# SERVICE BULLETIN

Service Bulletin No.: DA20-77-03 Rev 1

Title: Superior Labs Tachometer Installation

Figure 1

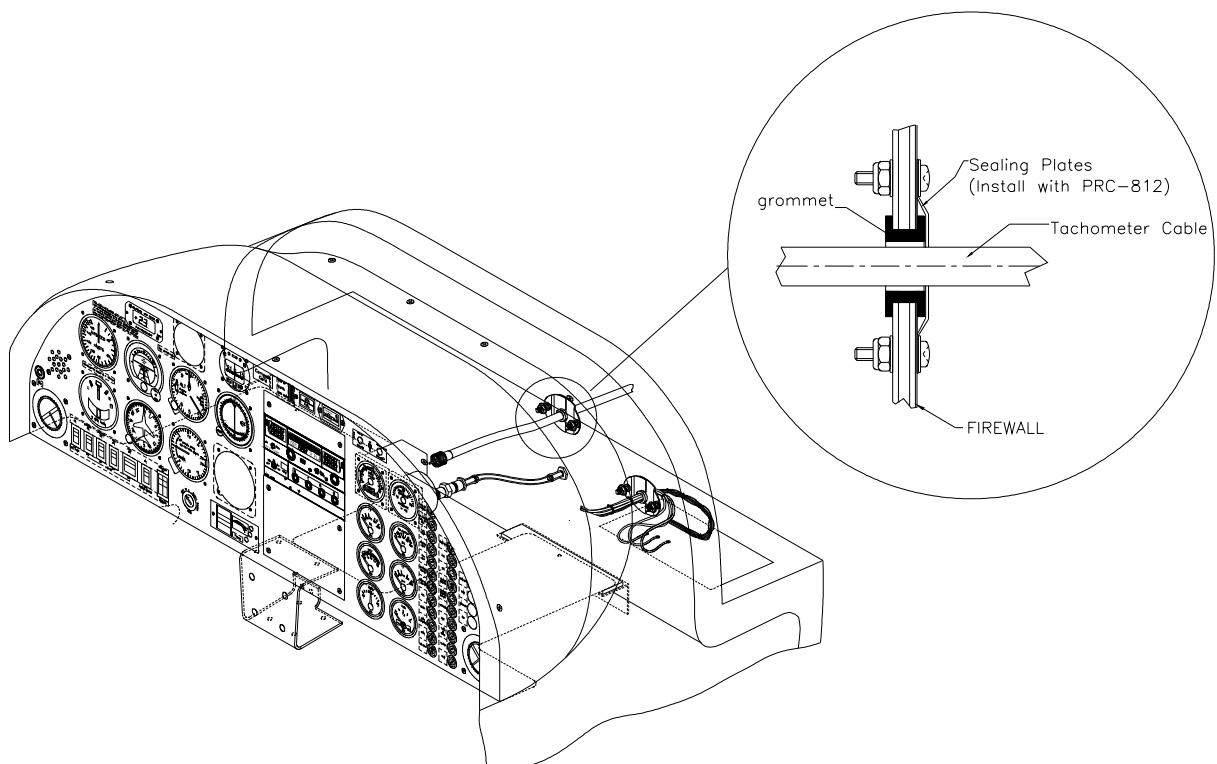
- 10.9.** Cut the grommet to prepare it for installation. Reference figure 3.
- 10.10.** Install the grommet and firewall sealing plates with the previously removed hardware and PRC 812 sealant. Refer to figure 1.
- 10.11.** Reconnect the battery leads (connect the positive lead first).
- 10.12.** Reinstall the instrument panel cover and the engine cowlings.
- 10.13.** Run the aircraft and verify the tachometer's accuracy.
- 10.14.** Make log book entries stating that this service bulletin has been accomplished.

- 11.7. Stow the three previously capped wires by tie wrapping them to the adjacent wire bundles.
- 11.8. Remove the blanking plate from the firewall where the tachometer cable will be routed. Clean the sealant from the firewall. Refer to Figure 1

- 11.13. Cut the grommet supplied to prepare it for installation. Reference figure 3.
- 11.14. Install the grommet and firewall sealing plates supplied with the kit using the removed hardware and seal with PRC 812 sealant. Refer to figure 1.

Figure 2

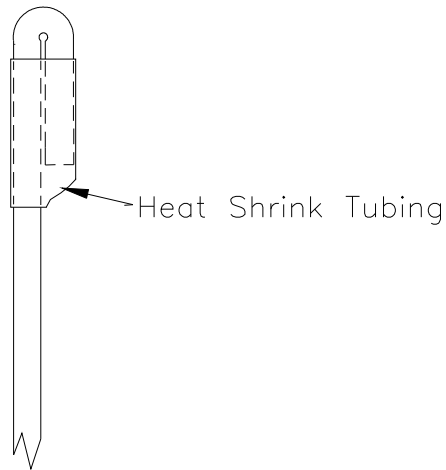
- 11.1. Remove the instrument panel cover.
- 11.2. Remove the engine cowlings.
- 11.3. Disconnect the battery leads (remove the negative lead first).
- 11.4. Remove Wire 77207A22 from the tachometer and isolate the plug by using the supplied heat-shrink tubing as shown in Figure 2.

- 11.5. Remove Wire 77208A22N from the tachometer and isolate the plug by using the supplied heat-shrink tubing as shown in Figure 2.
- 11.6. Remove Wire 77209A22WH from the tachometer and isolate the plug by using the supplied heat-shrink tubing as shown in Figure 2.

Figure 4

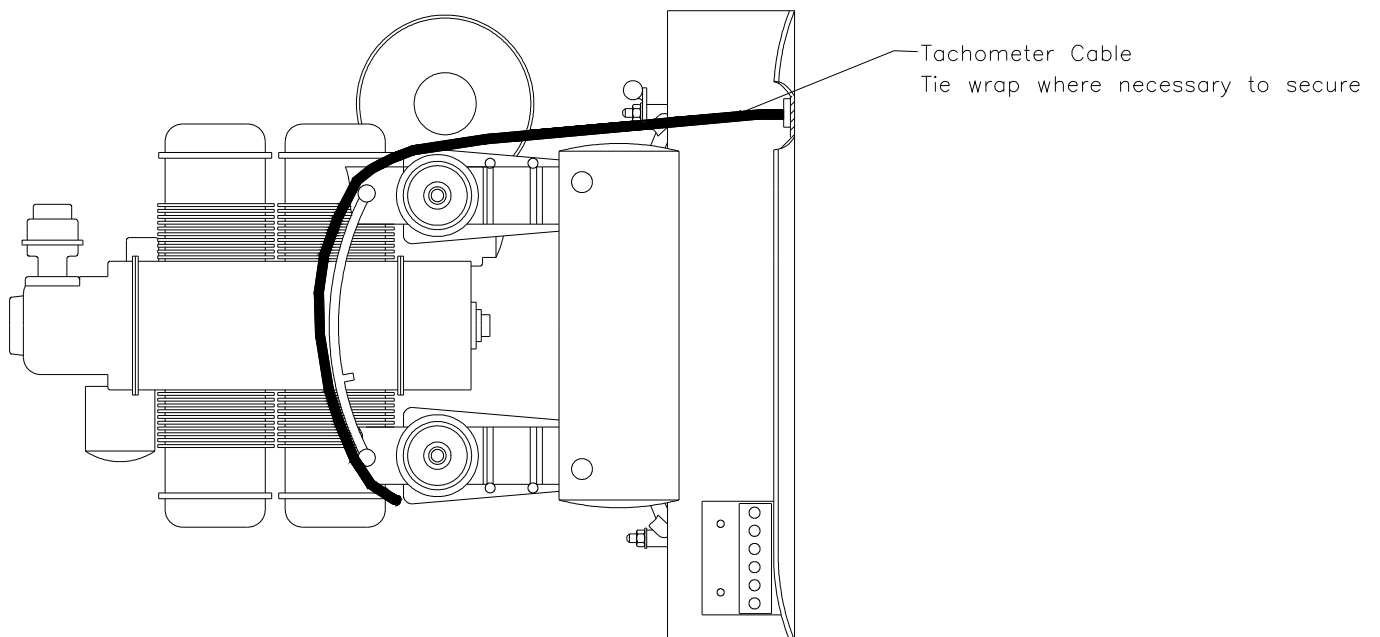
- 11.12. Install the new Superior labs tachometer cable following the routing shown in figures 4 and 5. Place the firesleeve on the engine end of cable. Reference figure 5. Tie wrap where necessary to secure.

**Figure 5**

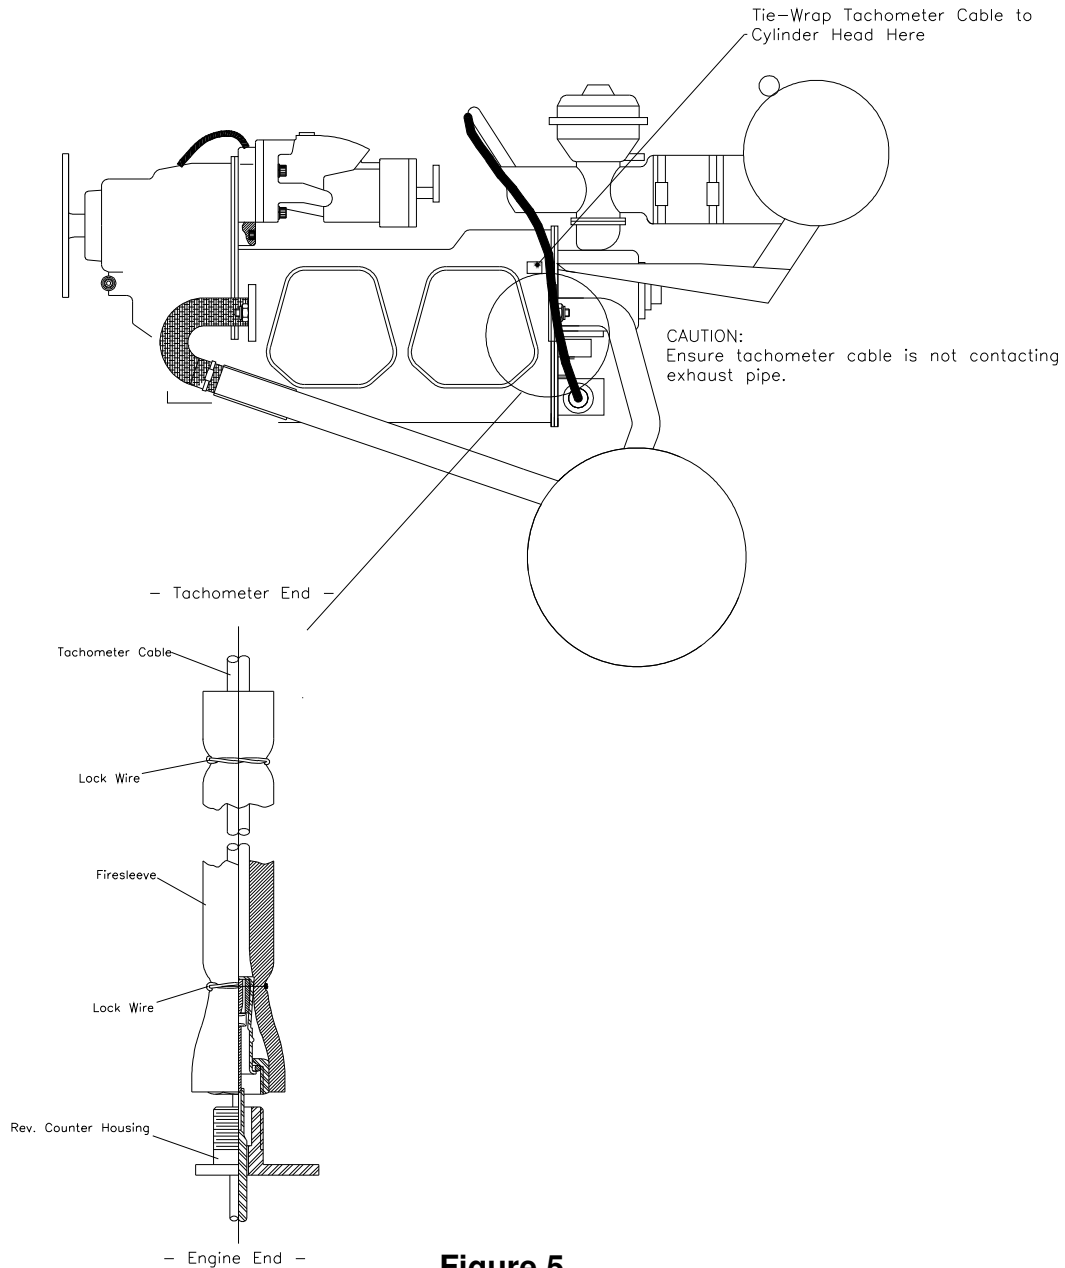
- 10.1.** Remove the instrument panel cover.
- 10.2.** Remove the engine cowlings.
- 10.3.** Disconnect the battery leads (remove the negative lead first).
- 10.4.** Remove the tachometer from the instrument panel and retain the hardware for re-use.
- 10.5.** Remove the sealing plates for the tachometer cable at the firewall and remove the tachometer cable (ref Fig. 1).
- 10.6.** Clean the PRC sealant from both the sealing plates and the firewall.
- 10.7.** Install the Superior Labs tachometer with the previously removed hardware.
- 10.8.** Install the new Superior Labs tachometer cable following the removed cable's routing, reference figures 4 and 5. Place the fire sleeve on the engine end of cable. Reference figure 5. Tie wrap where necessary to secure.

The tachometer cable must be secured against contacting the exhaust system.
